Access Compliance Report Public Rights-of-Way (Curb Ramps)

Main Street: BRIMHALL_DR Cross Street: CHRISTY_LN Location: SE

ADA ID: RPRK211207131843 Ramp Type: Type 1 - Perpendicular Diagonal Initial Pass/Fail: Fail Overall Compliance: No Severity Score: 2

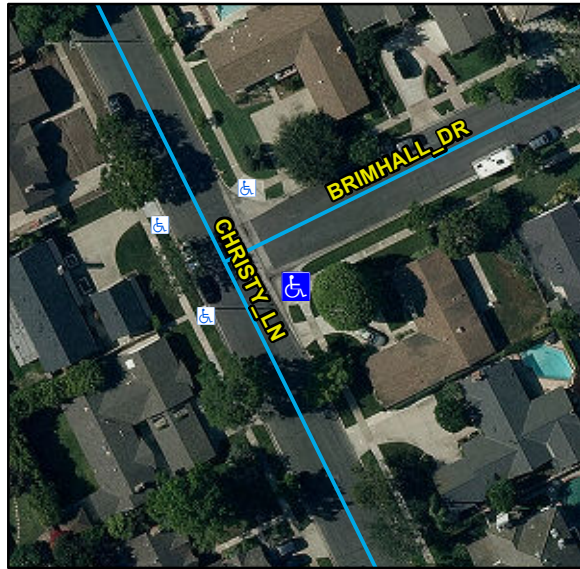
R204.3, R304.5.3, STD 1115

Remove & Replace Curb Ramp With Two New Directional Ramps or Equivalent.
